Delegated Report		Analysis sheet		Expiry Date:	03/10/2024
		n/a		Consultation Expiry Date:	15/09/2024
Officer			Application Numbers		
Tony Young			1. 2024/3309/P 2. 2024/3440/A		
Application Address			Drawing Numbers		
Pavement outside The Holborn Hotel on north side of Theobald's Road at junction with Old Gloucester Street London WC1B 4AR			Refer to draft decision notice		
PO 3/4	Area Team Signature	C&UD	Authorised Officer Signature		
Proposals					
<ol style="list-style-type: none"> <u>Planning application</u> - Installation of a Pulse Smart Hub with integrated digital screens and emergency functionality including provision of defibrillators. <u>Advertisement consent application</u> - Display of illuminated content on digital screens integrated within new communication Hub. 					
Recommendations		<ol style="list-style-type: none"> Refuse Planning Permission Refuse Advertisement Consent 			
Application Types		<ol style="list-style-type: none"> Full Planning Permission Advertisement Consent

- 1.1 Planning permission and advertisement consent are sought for the installation of a free-standing Pulse Smart Hub with two integrated digital screens which display illuminated advertising

Images 1 & 2 – proposed communications hub with integrated display screens

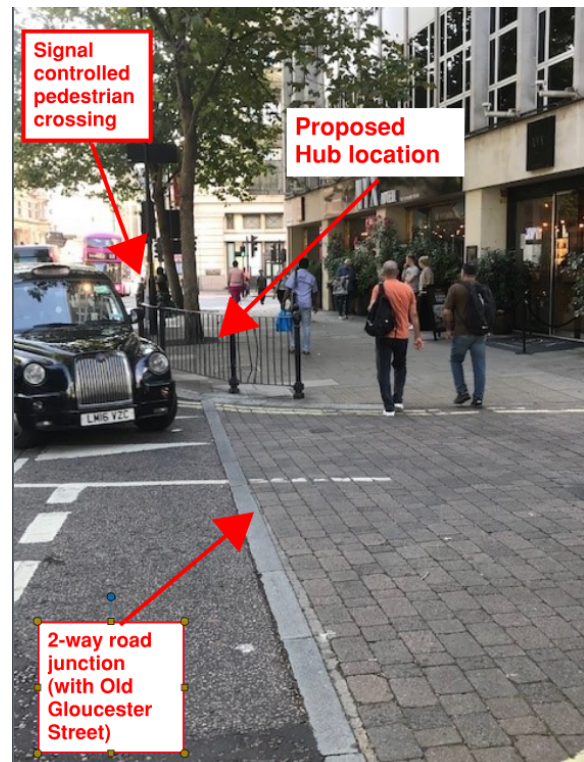
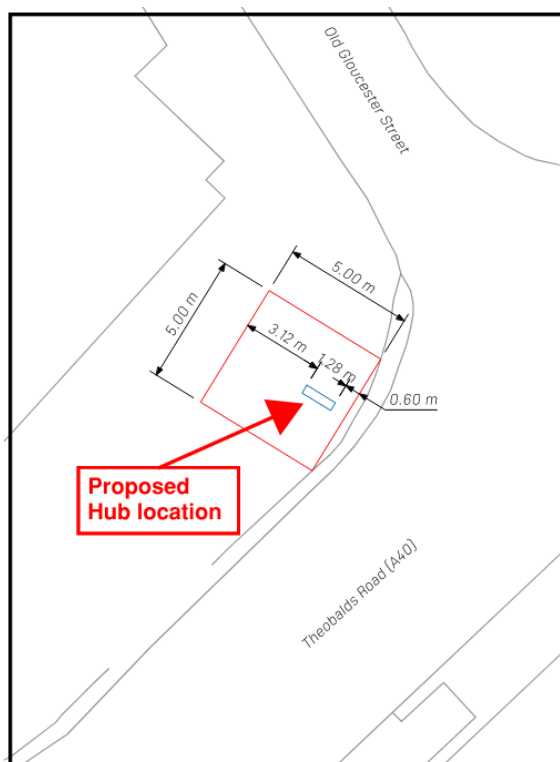
- 3.11 The proposed hub structure is considered to be poor in design terms and appears to have been primarily designed around the inclusion of two large digital screens on each of the main elevations. It would seem from the images of the proposed hub included within the application submission (see Images 1 and 2 above) that the size of the hub unit itself has been determined by the dimensions of the advertising panels. As such, the two illuminated digital advertising display screens occupy the majority of area available on each elevation of the structure (facing south-west and north-east respectively).

- 3.13 However, this has not been the case and the design approach has resulted in the creation of a large monolithic structure which gives the overall appearance as a large free-standing, advertisement panel rather than a structure for any other purpose.

Image 5 – comparison of different communication kiosks/hubs (proposed hub structure in red)

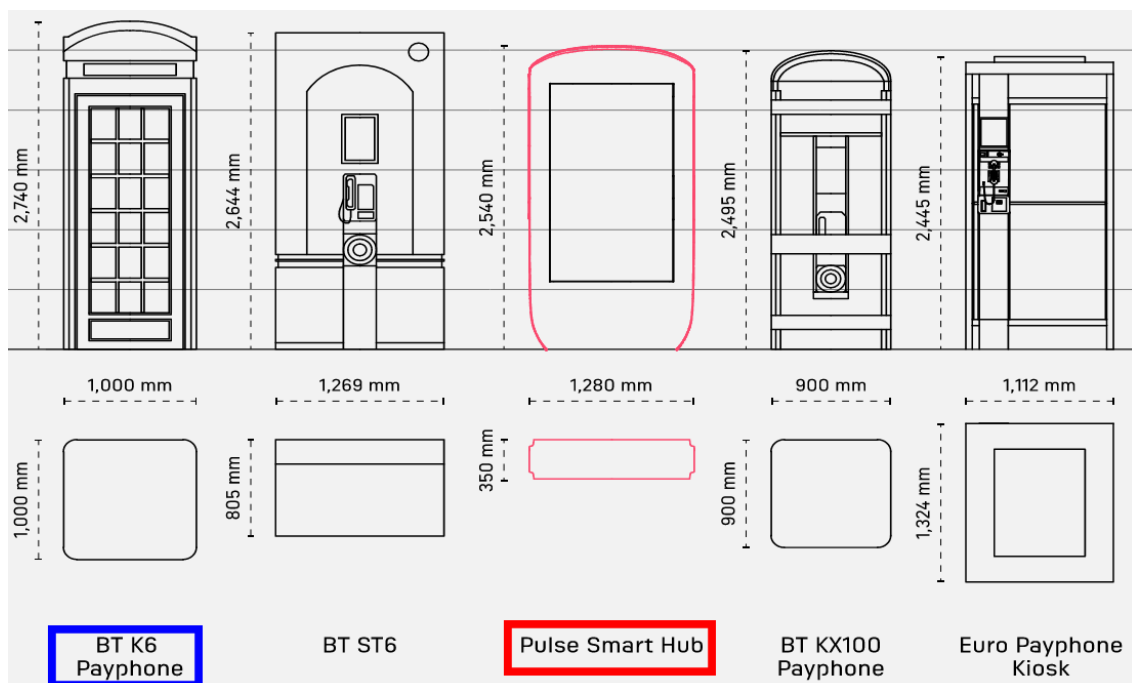
- 3.14 The dark grey anodised metal, black and clear laminated glass with textured fiberglass would have a shiny finish and incongruous contemporary appearance within the streetscene. While the applicant's planning statement describes the design of the proposed hub as referencing a traditional red phone box, it is the Council's view that the proposed structure bears little relation. Indeed, a comparison of both a traditional red phone box and the current proposal as shown in the application submission not only shows a lack of similarity in design of them both, but also a substantially larger profile (see Image 5 below).

- 3.17 Whilst the proposed hub structure is shown in Image 5 above to have a smaller footprint than, say, a traditional red telephone box, this is primarily through a difference in depth rather than in width. Any difference therefore is not something that would be experienced by a pedestrian as the large width and profile of the proposed structure would be most noticeable and prominent to the pedestrian on approach, restricting their views and visual amenity in this context. Additionally, it is emphasised that there is no kiosk or hub of any kind in situ in this location, and therefore, a comparison of footprint dimensions with a traditional telephone box (or indeed any other communications kiosk/hub) is considered to be mainly irrelevant as the proposals are not for a replacement structure, but rather would introduce a new item of street furniture to an area of public highway that is presently open and uncluttered.

- 3.18 Furthermore, there is nothing distinctive or responsive to context within the proposal, particularly when combined with its uncompromising bulk, and as such, it would appear as a prominent and discordant feature in the streetscene. In this regard, the unit is not considered to be the high quality design that Camden expects across the borough's buildings, streets and open spaces, but rather, would add a visually obtrusive and dominant piece of street furniture that is out-of-keeping with the existing uncluttered streetscene,

Image 6 – showing approved tables & chairs zone for hotel adjacent to application site (extract)

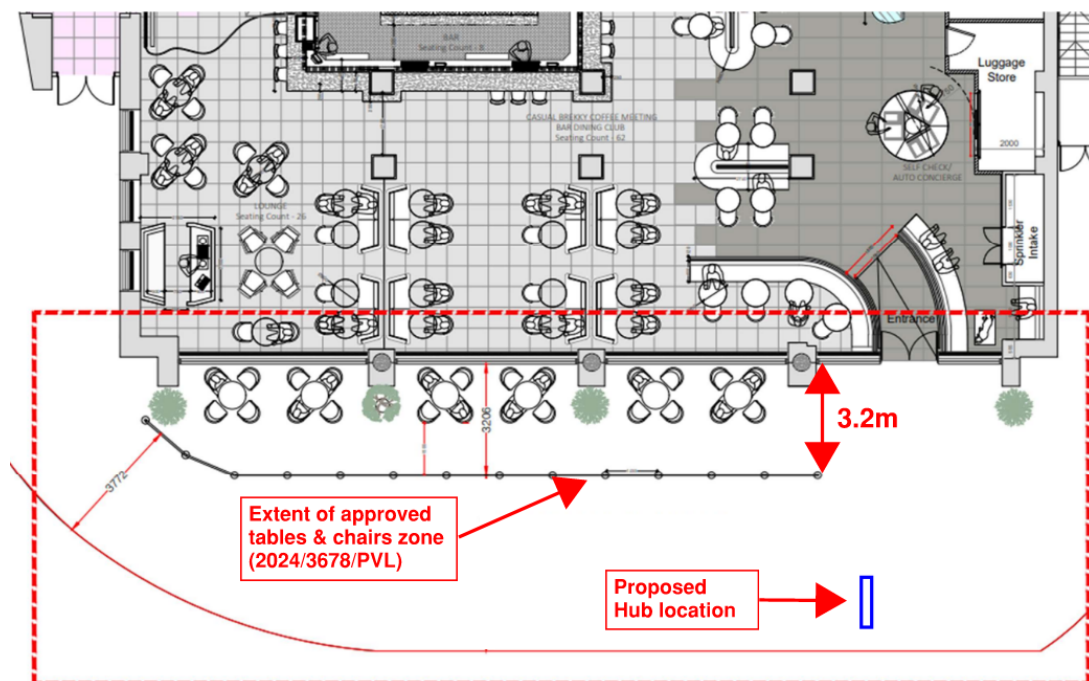
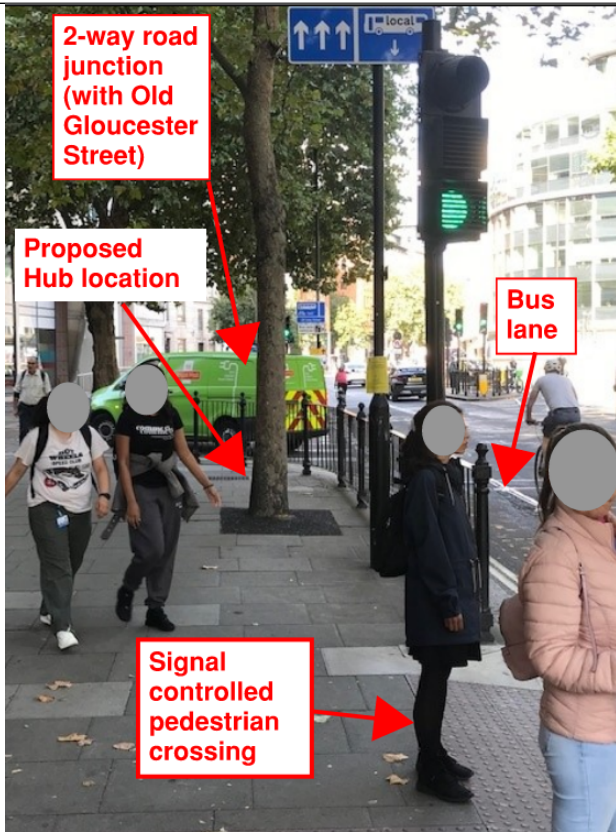
3.53 However, it should also be noted that the submitted plans fail to show a 3.2m wide tables and chairs zone adjacent to the Theobalds Road frontage of the adjacent NYX Hotel. The Planning Inspector when considering a previous appeal at the site (ref. APP/X5210/W/18/3195372 – Appendix A) dated 06/08/2018 (see 'Relevant history' section above for details) stated that no details were provided in regard to tables & chairs in that case. Image 6 is therefore now included below which has been taken from a recent Tables & Chairs application submission submitted in 2024 and which shows a layout plan.

3.54 The approved tables and chairs zone (ref. 2024/3678/PVL) is shown in Image 6 as measuring 3.2m, and as such, has a significant impact on the amount of pavement space available for pedestrian movement. As a result of this, and taking into account the application proposals to site a hub structure, the available effective footway would be reduced to approximately 3.5m.

Image 9 – showing proximity of proposed hub structure (blue) to a signal controlled pedestrian crossing and road junction with Old Gloucester Street (extract drawing)

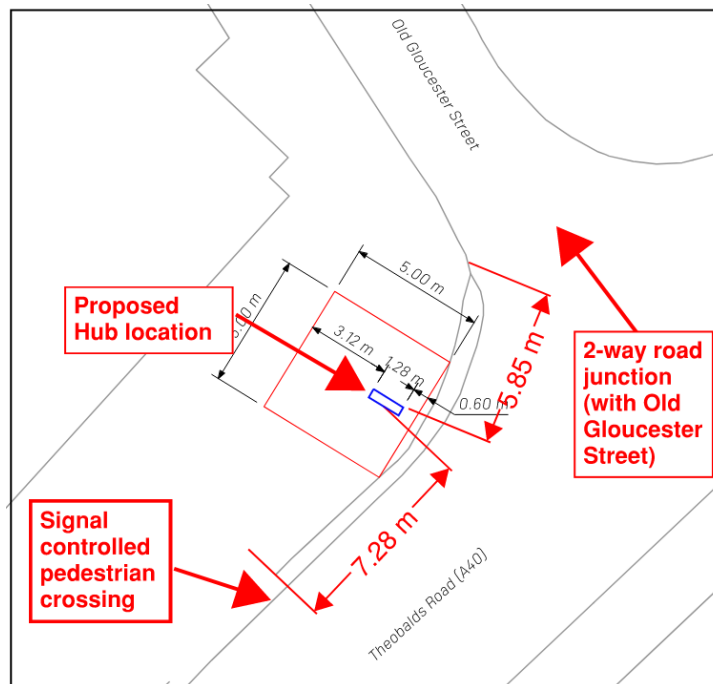
3.63 Images 7 and 8 above indicate that the proposed hub structure (with integrated digital advertising screens on both sides) would be installed within approximately 8m of a busy signal controlled pedestrian crossing located to the south-west, contrary to the above Transport for London guidance. This degree of proximity is also shown in Image 9 below which has been scaled and measured from the applicant's submitted drawings pack.

3.64 The proposals would therefore introduce a significant distraction to pedestrians attempting to use the crossing given the close proximity of both in relation to each other, by virtue of the structure's size, location, illuminated displays and orientation. The proposal would also lead to a
